Work Order ID 132449

Item ID: D350-607-541 Accept *N900040100* Setup Start *NS1*
 Revision ID: Stop *NS2*
 Item Name: Quick Release Heli-Utility-Basket™ Long, HD Lid, Spacepod™/Squirrel Cheek Comp.
 Start Date: 4/30/15 Start Qty: 1.00 *1* Cust Item ID:
 Required Date: 5/08/15 Req'd Qty: 1.00 *1* Customer:
 Reference:

DART SERVICE INSTRUCTION

TO AMEND INSTALLATION INSTRUCTIONS D350-607-3 Rev.D,
INSTALLATION INSTRUCTIONS D350-607-4 Rev. C AND
INSTRUCTIONS FOR CONTINUED AIRWORTHINESS ICA-D350-607 REV. 6
REF TCCA STC: SH94-14
REF FAA STC: SR00213NY
REF EASA STC: EASA.10016996
REF BRAZILIAN STC: 2007S03-03/-04/-05/-06

FIGURE 1: INSTALLATION OF D4775-041 FWD STRUT

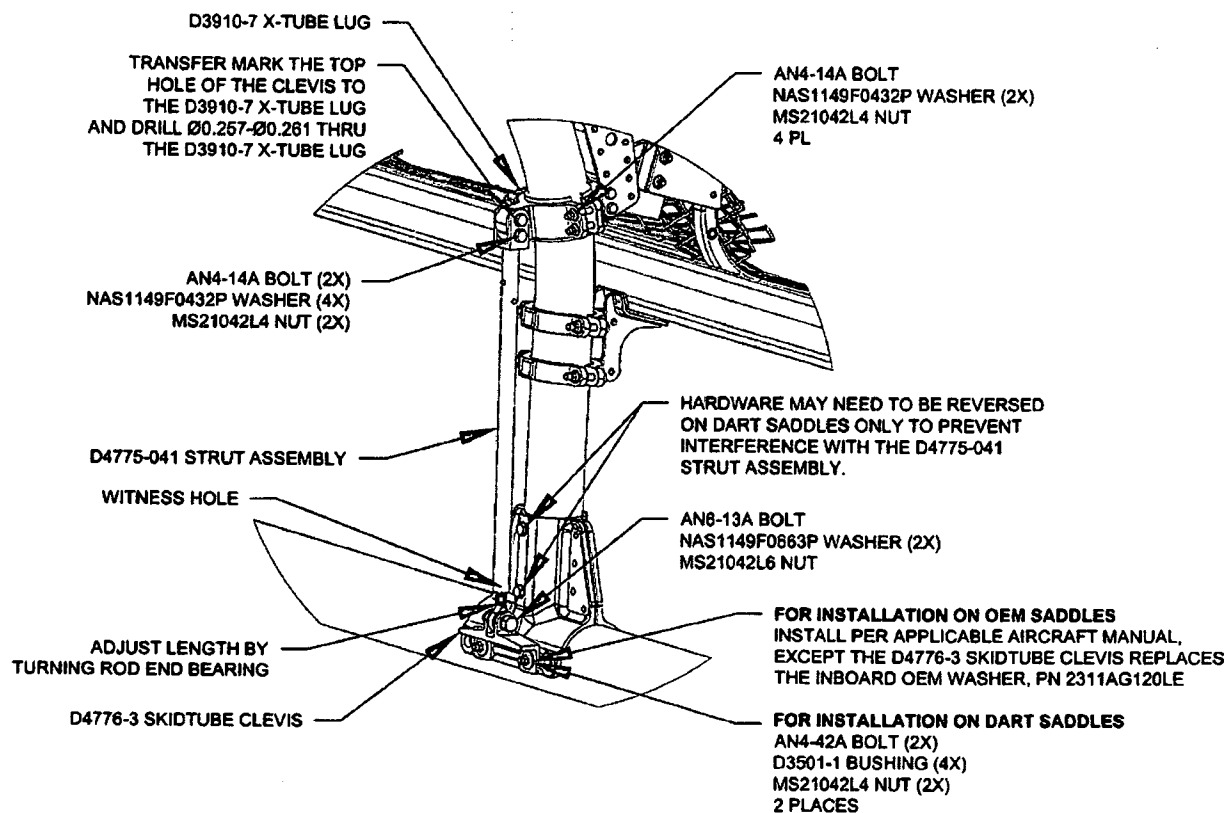
- 3.1 Substitute the Forward Lower D3910-5 X-Tube Lug with the D3910-7 X-Tube Lug as shown in Figure 1.
- 3.2 Install the forward D4775-041 Strut Assembly. Transfer mark from the upper hole on the clevis of the D4775-041 Strut Assembly to the D3910-7 X-tube Lug and drill thru the lug $\varnothing 0.257$ - $\varnothing 0.261$ as shown in Figure 1. Touch up chemical conversion coating per MIL-DTL-5541. Check the witness holes located at the bottom end of the D4775-041 Strut Assemblies to ensure that the thread from the rod end extends past the witness hole.
Torque MS21042L4/-4 nuts to 50-70 in-lbs (5.7-7.9 N-m). Torque MS21042L6/-6 nuts to 160-190 in-lbs (18.1-21.5 N-m).
- 3.3 Complete the installation in accordance with Installation Instructions D350-607-3 Rev. D or D350-607-4 Rev. C.
